Interactive comment on “Slope stability and rock fall hazard assessment of volcanic tuffs using RPAS and TLS with 2D FEM slope modelling” by Ákos Török et al.

Answers to the review of interactive comment on “Slope stability and rock fall hazard assessment of volcanic tuffs using RPAS and TLS with 2D FEM slope modelling” by Ákos Török et al. Anonymous Referee #2 Received and published: 15 April 2017
Reply: 10 June 2017

Fig. 3. The results of the global stability analysis of the slopes (sections 3 and 4 on Fig. 14), total displacements are marked in blue to red (lithology is indicated by letters A-D, note the weak zone)

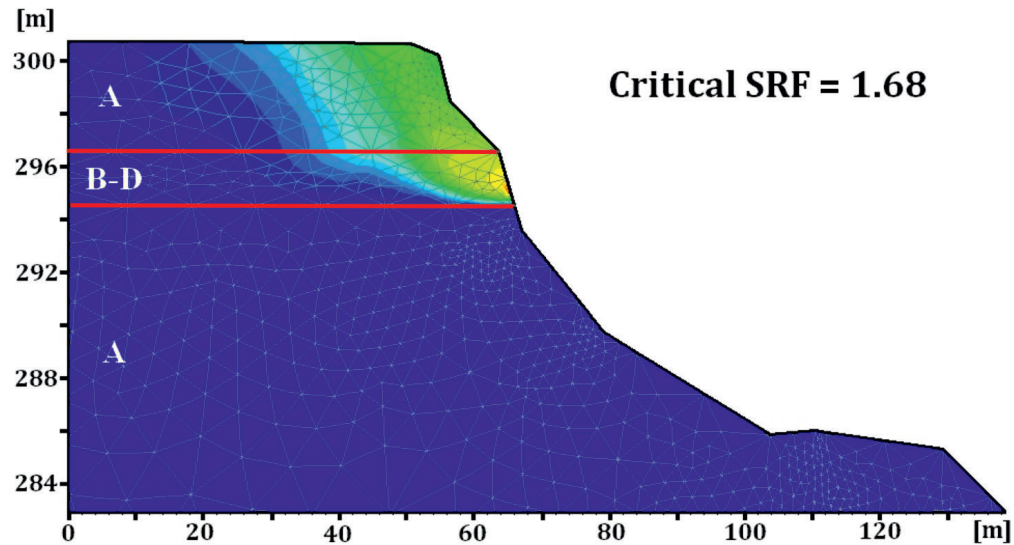
10) The result of the stability analysis is not clearly described. Even if the author state that the critical global factor of safety is above 1, they then indicate that "the failure occurs in the weak layer". . . In this way, it is not clear what the reader should conclude looking at the analysis. Probably they would state that the slope is stable in the modeled conditions but a perturbation might induce its failure with the formation of a slip surface that should nucleate from the weaker layer. Please clarify this aspect. Additionally, from the text it is not clear if the authors account for discontinuities in the global stability analysis.

Answer: The slope stability analysis was modified in the revised paper. A modified figure that shows the "weak layers" in the slope stability model was added to the revised manuscript, clearly marking the calculated slip surface at the weak layers. A new figure that describes the studied sections is now part of the revised manuscript. The difference between this model and the planar failure and wedge failure were described in more details. A figure that shows the joint orientation (and DEM model) explains better these types of potential failures.
